Planning Approval Consistency Assessment Form

Assessment Name:	Pyrmont Station – Integration with OSD
Prepared by:	Sydney Metro
Prepared for:	Sydney Metro
Assessment number:	SMW12
Type of assessment:	Assessment under EP&A Act 1979, Division 5.2
Version:	Final
Planning approval No. (where relevant):	SSI-22765520
Date required:	1 March 2024
iCentral number	SM-23-00450480

Appendix A – Indicative layout and key design elements – Pyrmont Station

Figure 2 - Indicative layout and key design elements – Proposed change

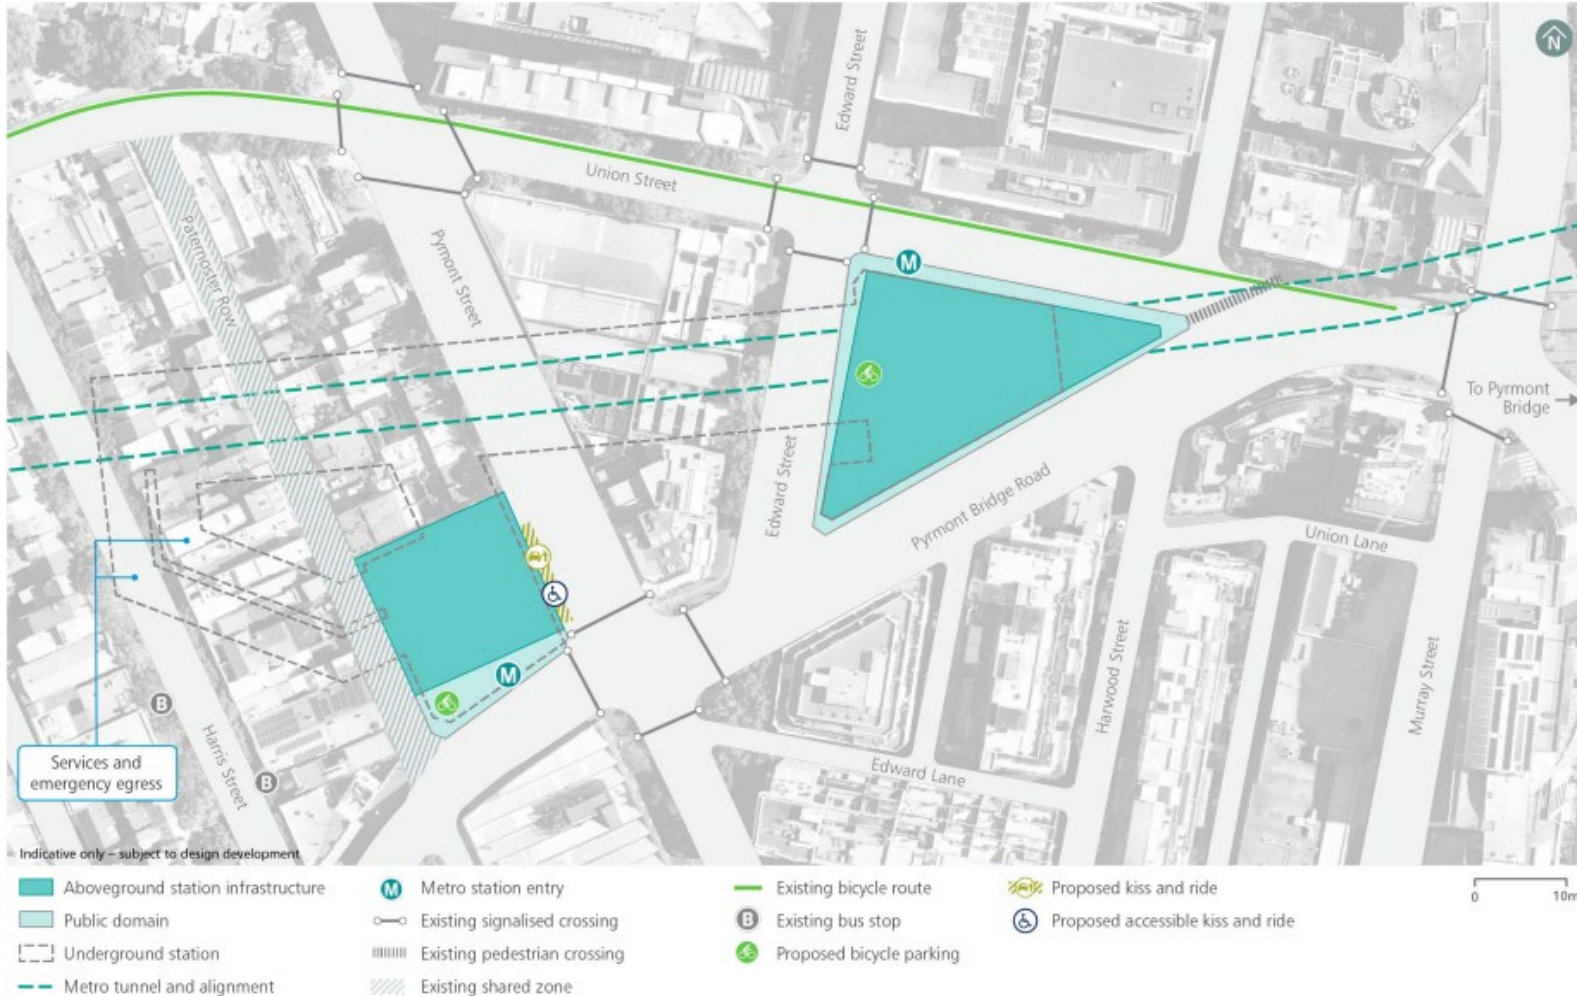
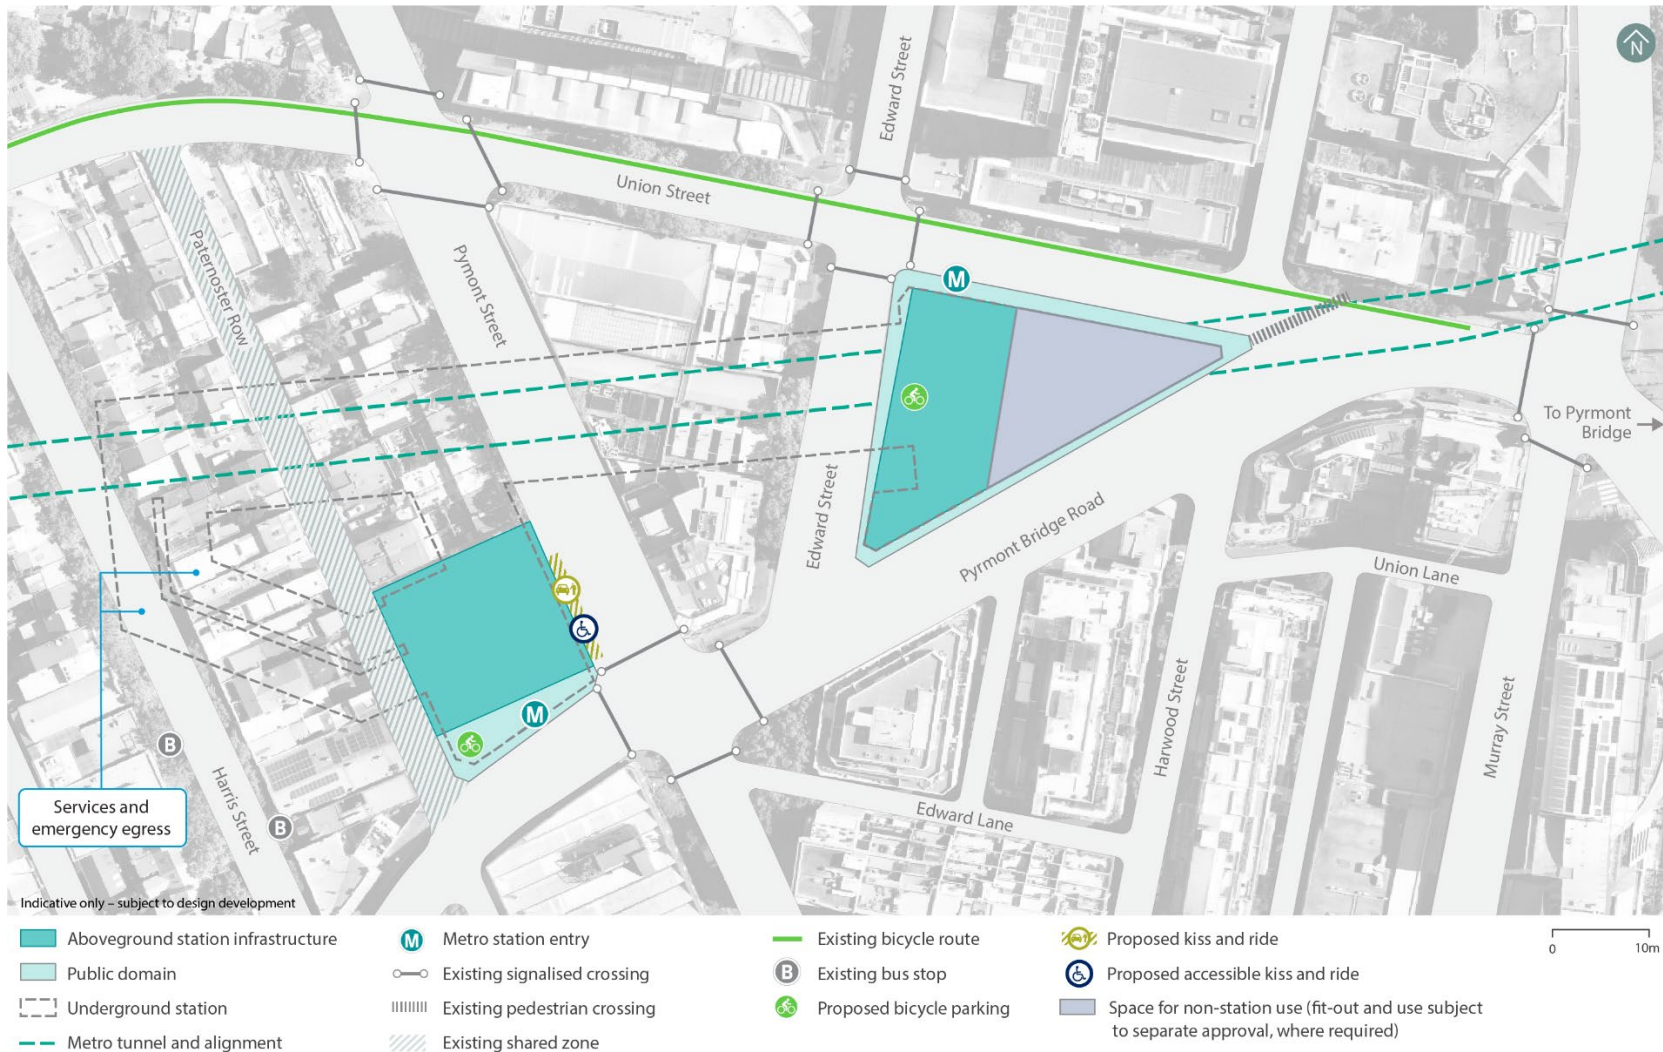
- an increase to the station's indicative podium height from the indicative 16 metres identified in the Response to Submissions Report (RtS) to a proposed indicative 27 metres
- an increase to the indicative construction timeframe for the station works by about 18 months (due to the increase in podium height).

A representation of the design at ground floor is shown at Figure 2 of Appendix A.

The proposed arrangement of the podium has resulted from a number of key design considerations. Spaces for station and services infrastructure have been arranged within the western portion of the podium due to the following reasons:

- key equipment including ventilation shafts require greater space above the station than previously assumed, and consequentially, would extend higher into the podium than the indicative height of about 16 metres identified in the EIS and RtS

- key station infrastructure, including ventilation shafts, must be located above the station to ensure operational efficiencies
- loading docks and the driveway for the integrated station podium and over station development must be located along Edward Street in order to prevent private and service vehicles interfering with heavy traffic and pedestrians on Pymont Bridge Road and Union Street

- enables provisioning of spaces along the frontage of Union Street for the station entrance, and ground floor active frontages in response to the strategic objectives outlined in the Pymont Peninsula Place Strategy (DPE, 2022) to promote Union Street as a local centre.

Figure 4 - Potential over station development extent - Proposed change

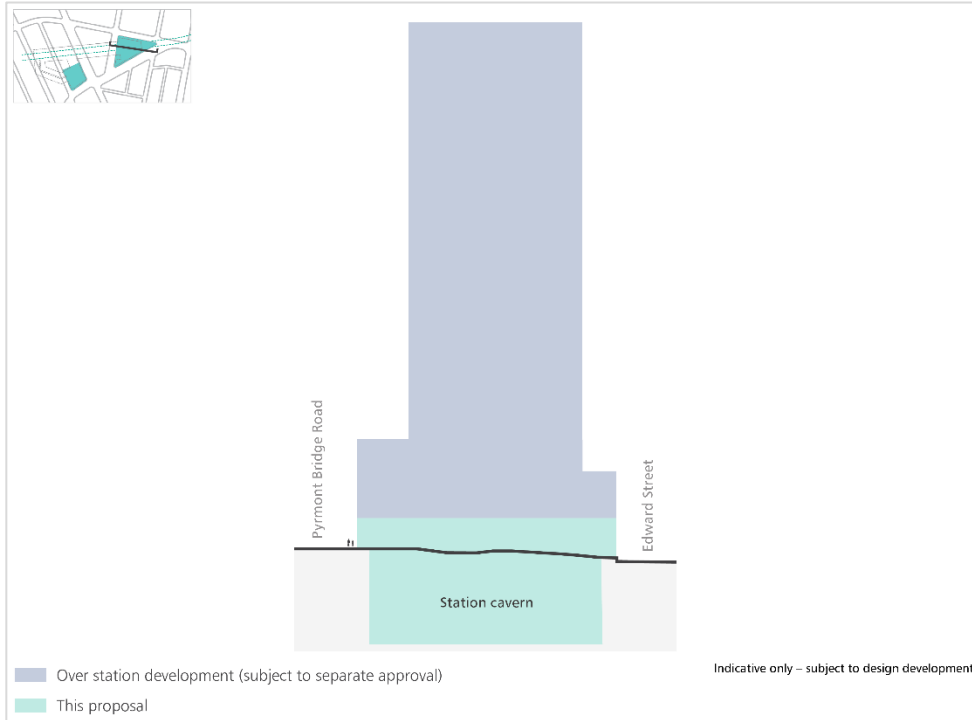
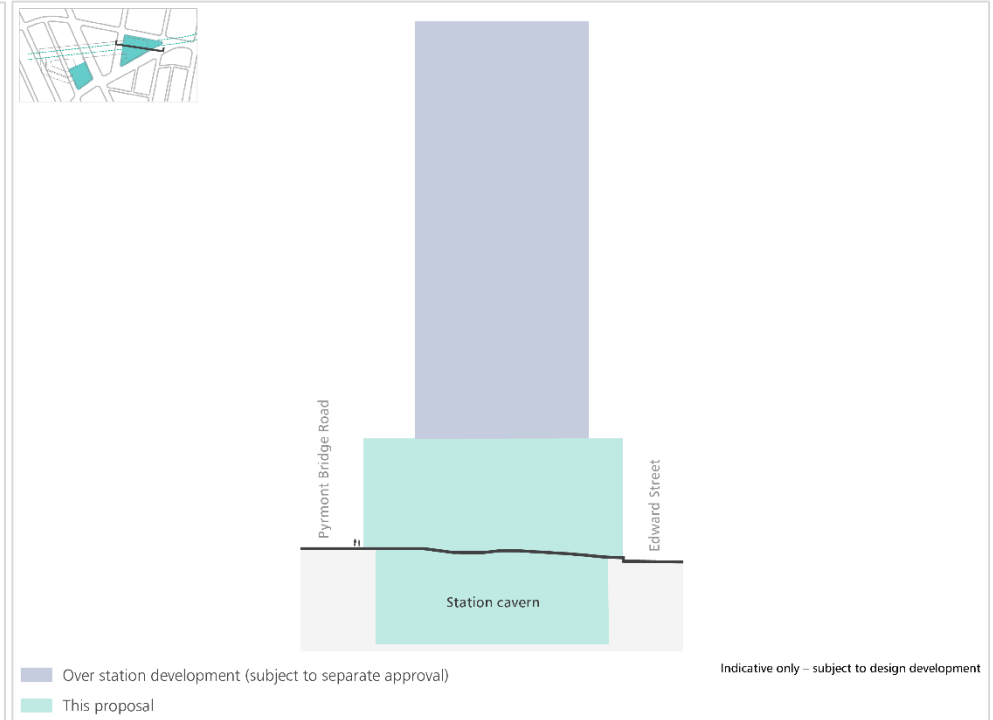
This Consistency Assessment assesses the construction of the full extent of the podium up to about 27 metres (RL 34.9) at the Pyrmont Station eastern site. Impacts associated with the construction and operation of the station and services infrastructure, and the delivery of the integrated structures and spaces for non-station uses within the podium, are assessed in this Consistency Assessment. These impacts include those arising from the additional construction timeframe to deliver the refined station podium. Impacts associated with the fit out and use of the non-station spaces within the podium, and the over station development (including the overall building height and floor space), are not assessed in this Consistency Assessment and are subject to separate approval. The EIS for the Concept SSDA will assess the over station development above the station podium, as well as the uses of the non-station spaces within the podium. All works associated with the proposed refinement to the indicative podium height would be undertaken in accordance with the Conditions of Approval, including the approved construction hours specified in Condition of Approval E25.
